Meeting Agenda

Franklin Municipal Planning Commission

Thursday, July 25, 2019

WOOD DUCK COURT PUD SUBDIVISION
 RESOLUTION 2019-56
 ORDINANCE 2019-20
 FRANKLIN MUNICIPAL PLANNING COMMISSION
 06/27/2019

EXISTING
CONDITONS
SHEET
CI.1
COF 6991

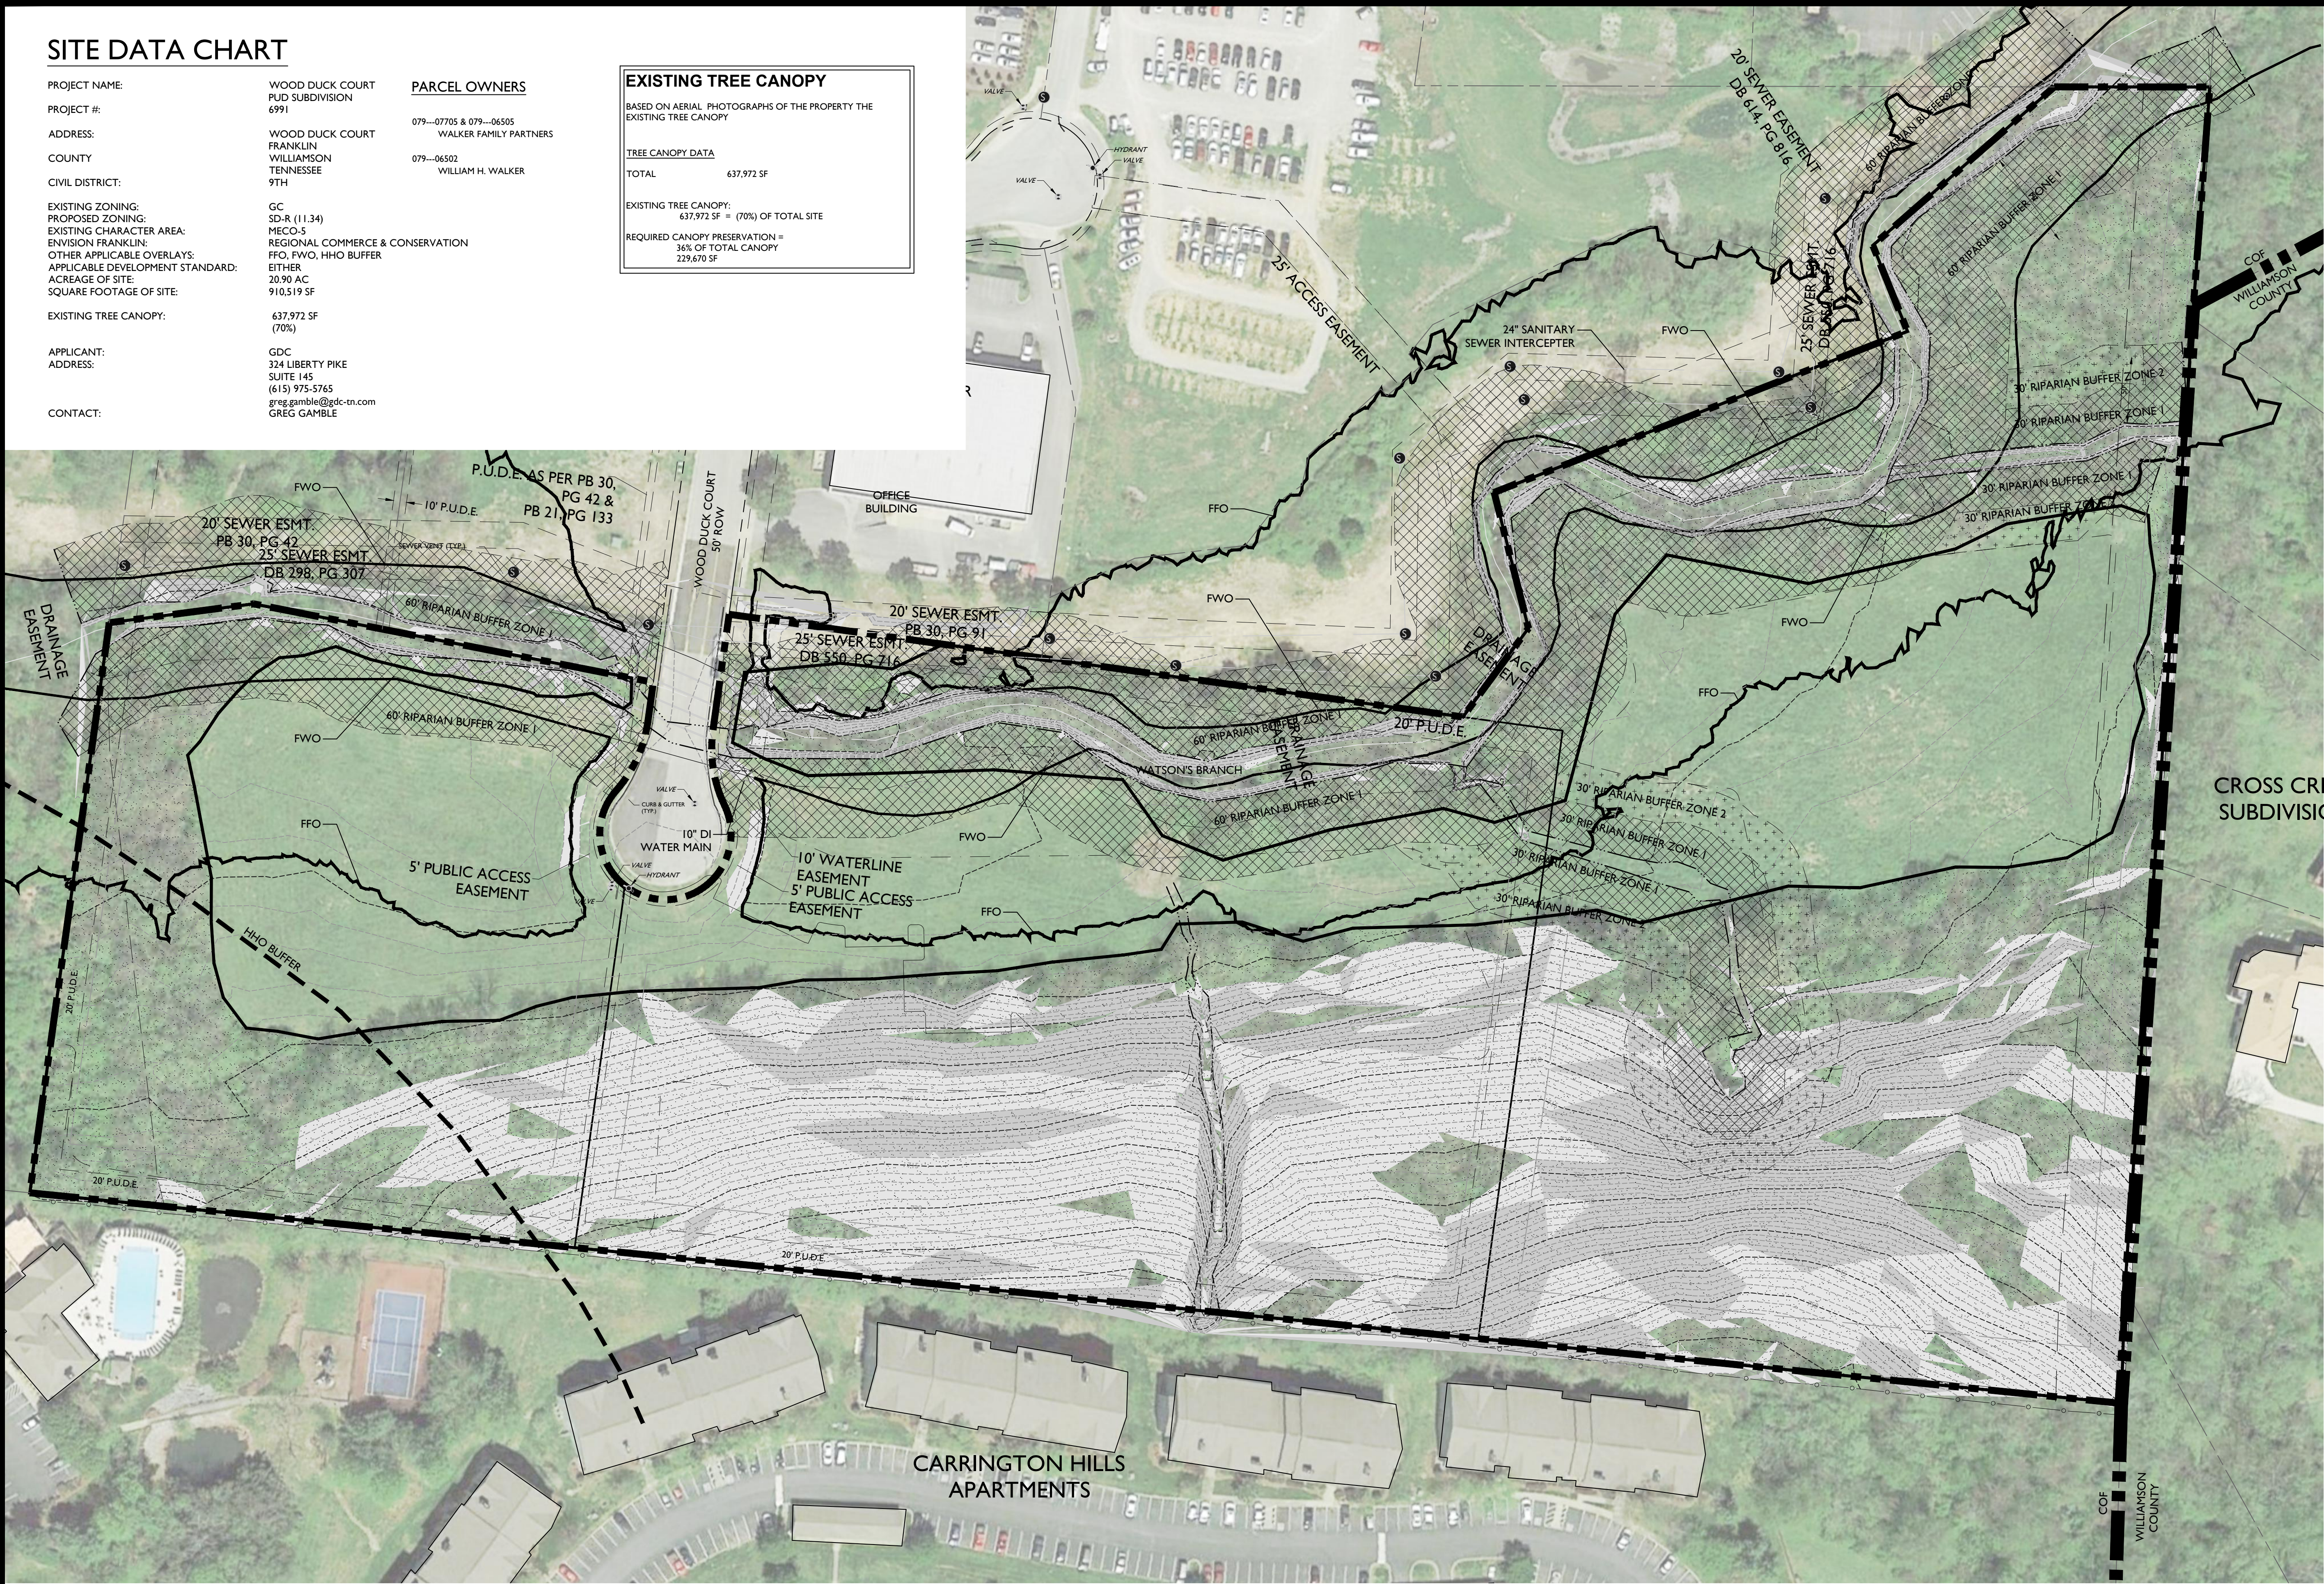
Applicant to show existing easements on the Existing Conditions Sheet C1.1, similar to that shown on the previous submittal.

SHEET
C2.0

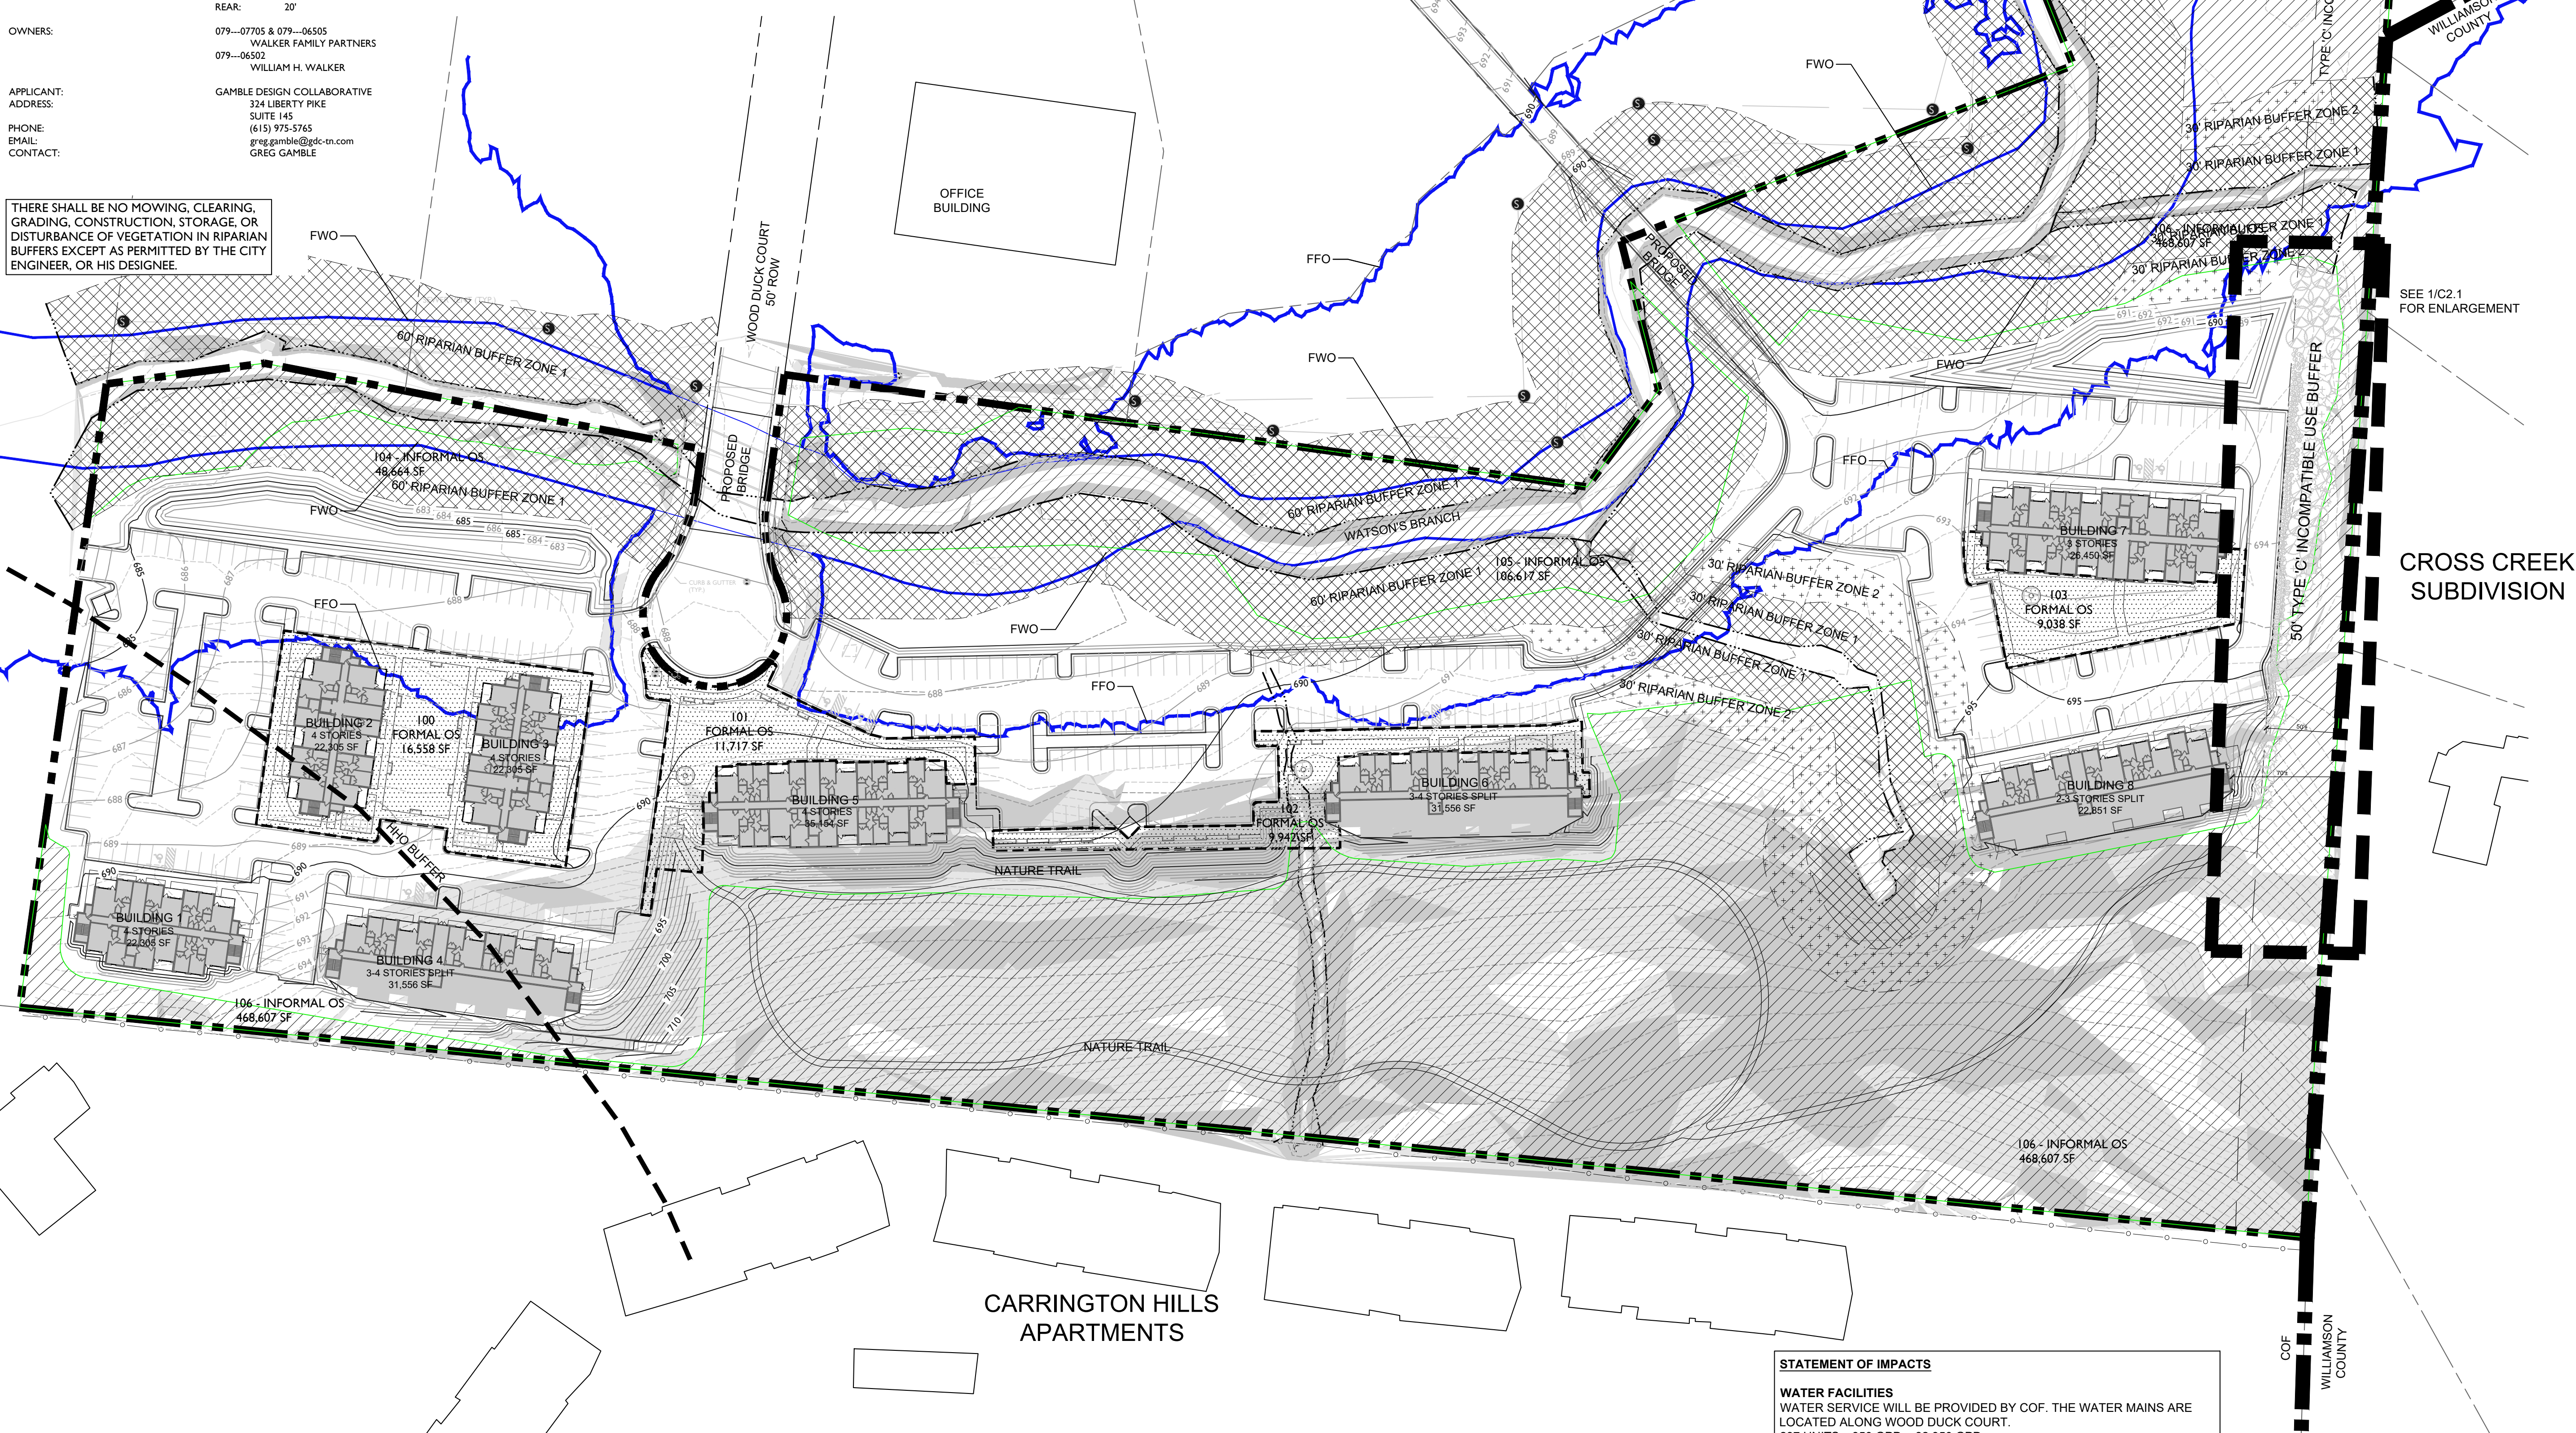
Identify the sidewalk between buildings 6 and 7 in more detail on sheet C2.0. It is hard to see on current plans.
[Edited By Amy Diaz-Barriga]
